AMP 74 Vinette Tower Boiler Replacement

AMP 74 Vinette Tower Boiler Replacement, Syracuse NY
(revised March 5, 2021, issued with Addendum #1)

03/05/2021 Addendum No. 1

ROOF PLAN
SCALE: 1/8" = 1'-0"
1 M104 AD1

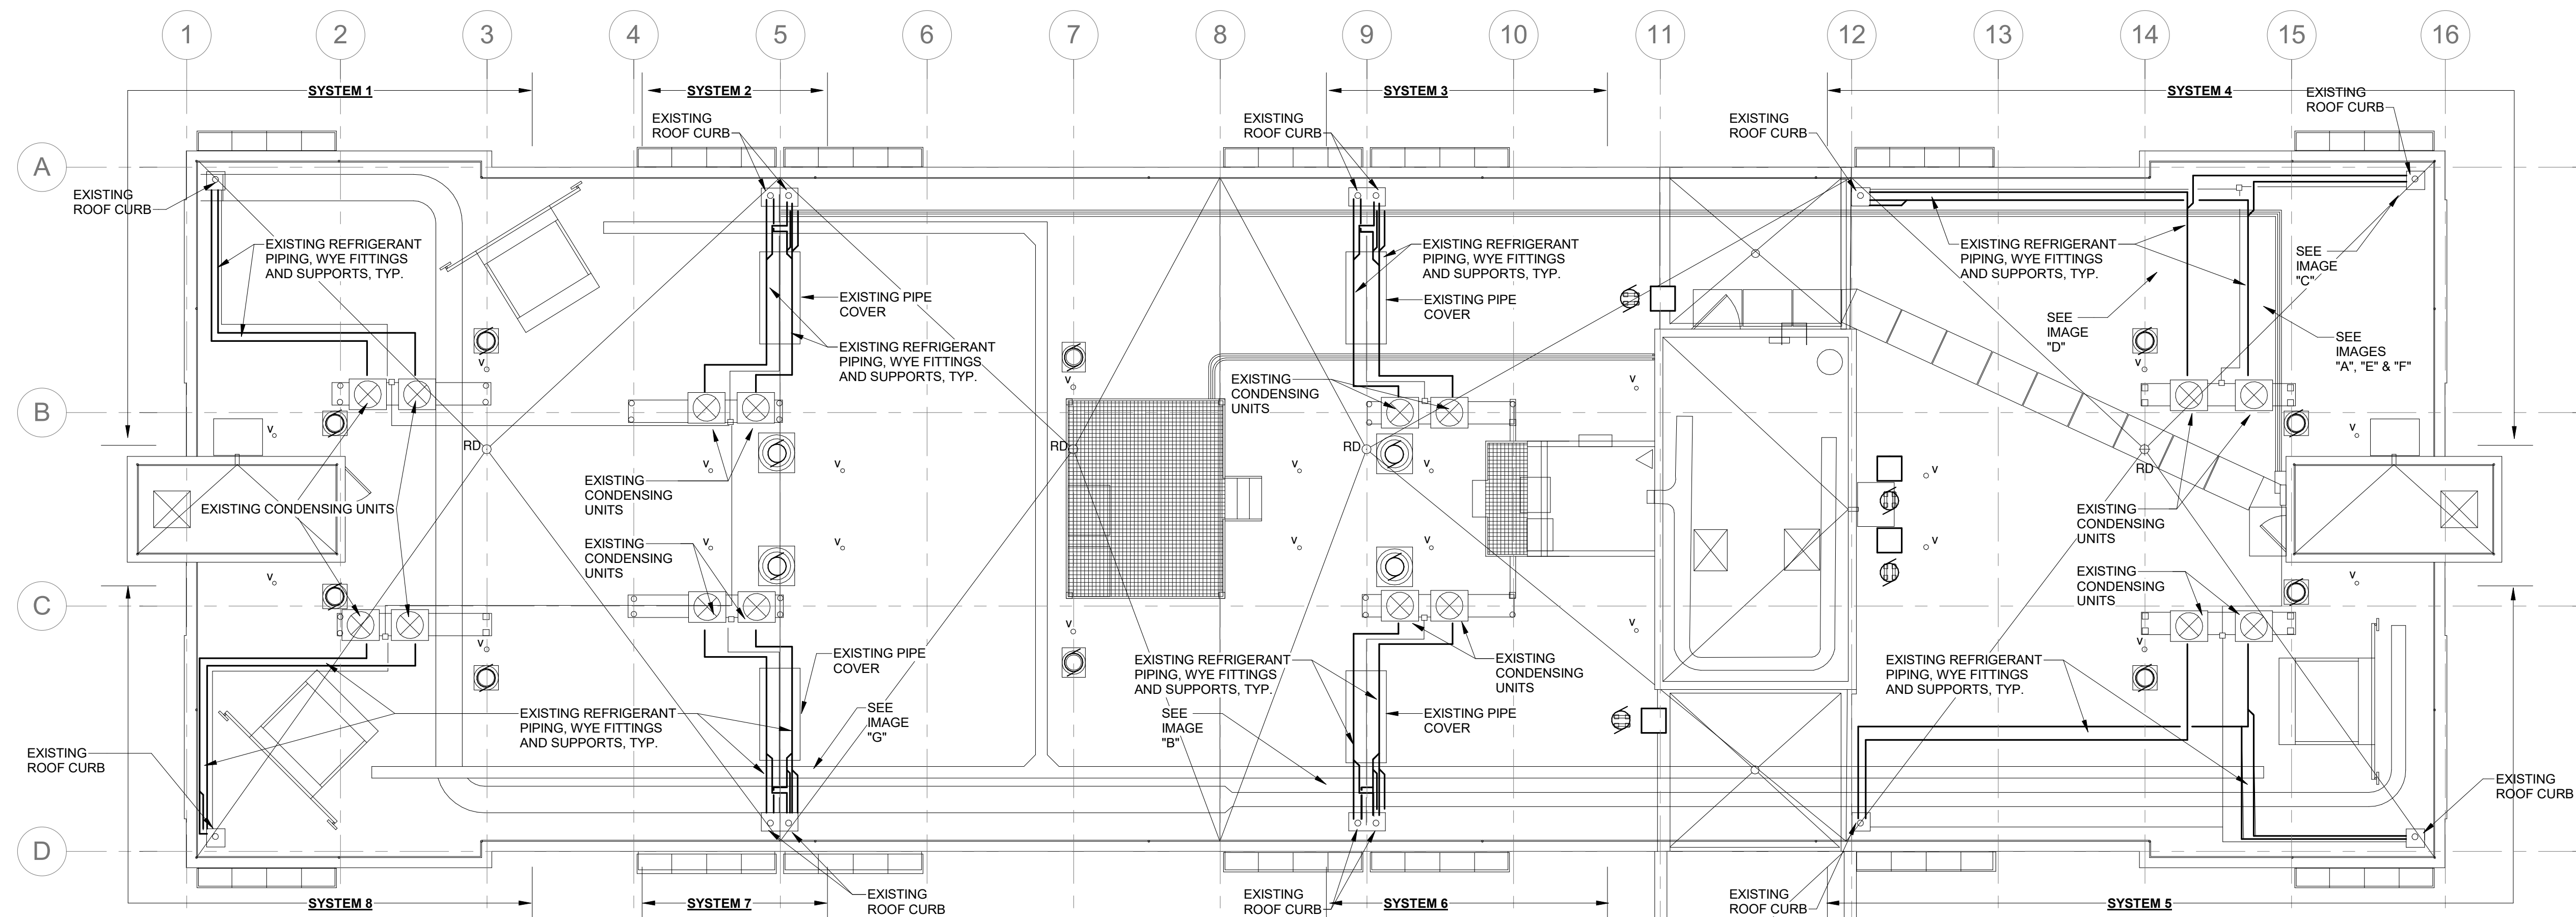
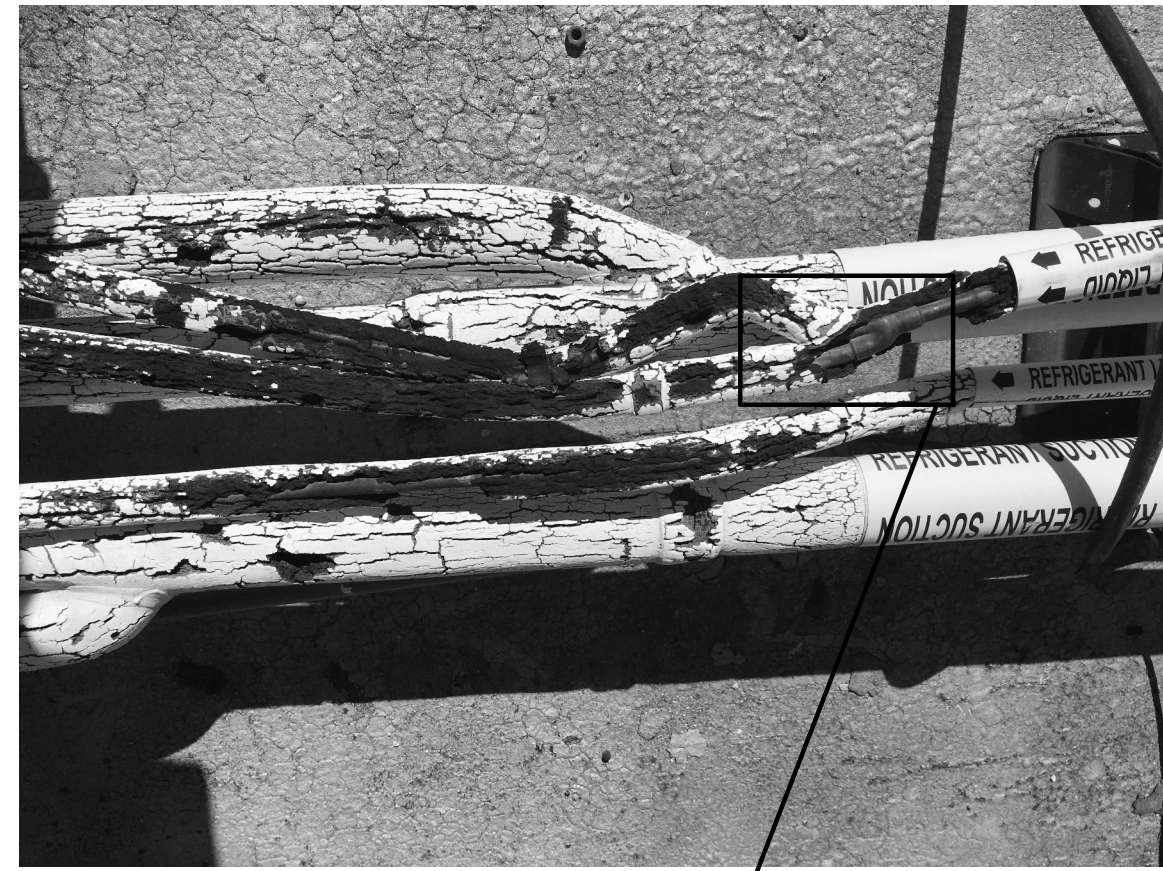
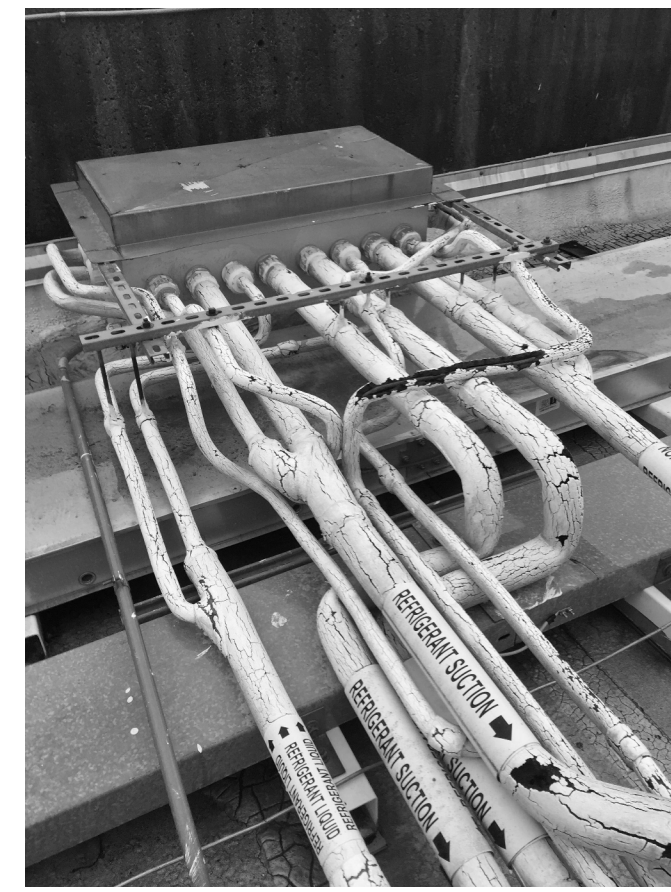
1. Div 00 Bid Form – REPLACE Bid Form with Bid Form attached here.
2. Section 012300 – Alternates: Para 3.1 ADD “3. Alternate 3. ADD mechanical scope to replace existing insulation on VRF piping located on roof. Refer to drawings M104 AD1 and M105 AD1 attached.

4. Drawing M104 - Roof Plan – Alternate No. 3
 - a. DELETE drawing and REPLACE with attached Drawing M104 AD1.
5. Drawing M105 – VRF System Insulation Specifications – Alternate No. 3
